TECHNICAL SERVICE BULLETIN

Subject	PECL Fitting Replacement 35' FT
Issue Date	07/19/2023
Service Bulletin Number	SC-23-090
Models Affected	Service Specified Vehicles
Complete By	Next Service Opportunity
Labor Operation Code	CC65Z

This Technical Service Bulletin covers the procedure for replacing the Power Electronic Coolant Loop quick connect fittings with more durable brass fittings.

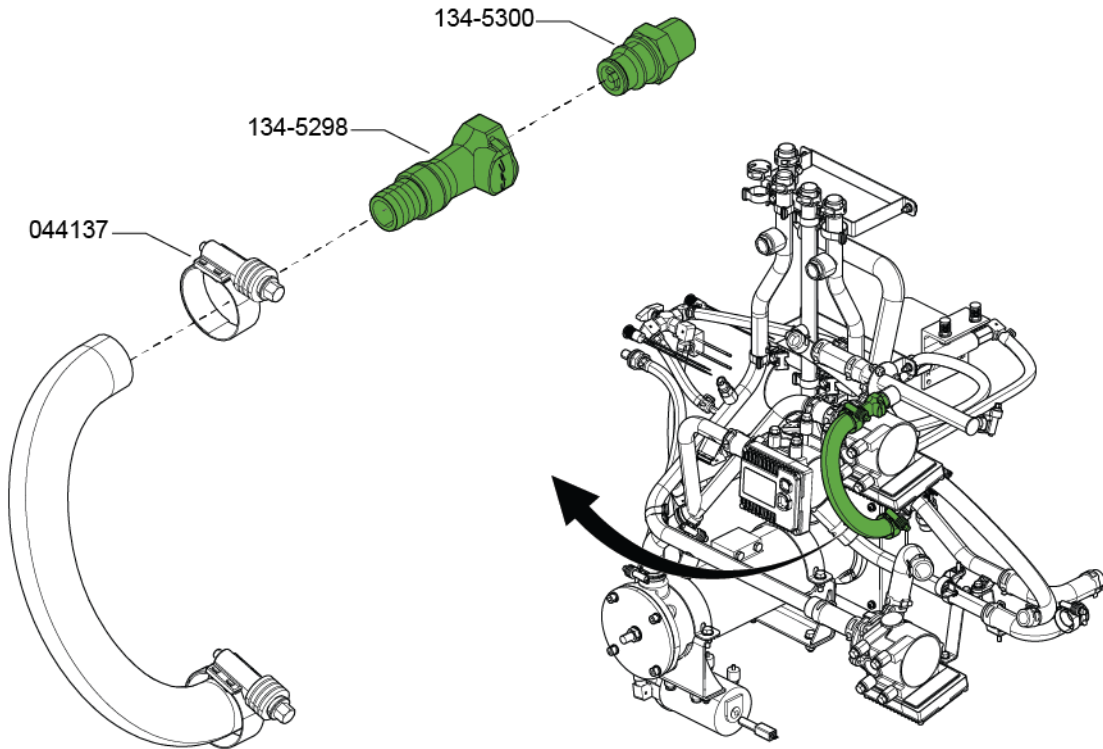
Loosen the worm-drive clamp and remove the quick connect fittings (134-5298 and 134-5300).

Step 3:

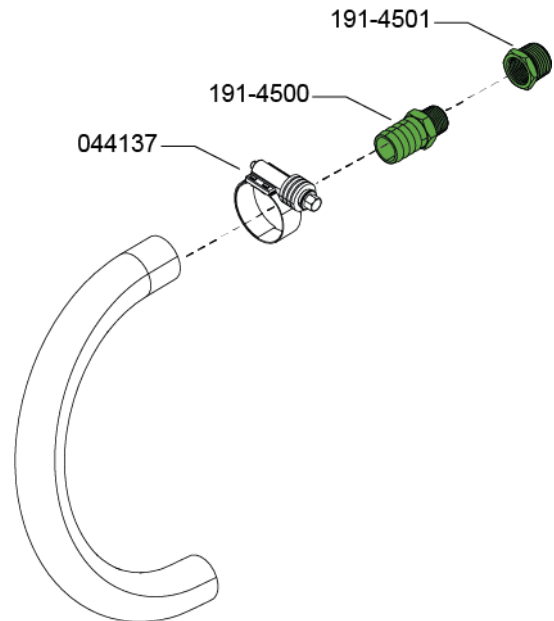
Wrap the threads of the new fittings (191-4500 and 191-4501) with Teflon tape and leave the last three threads exposed.

Install fitting 191-4501 into PECL hardline.

Thread fitting 191-4500 into 191-4501.

Attach hose and secure with worm-drive clamp.
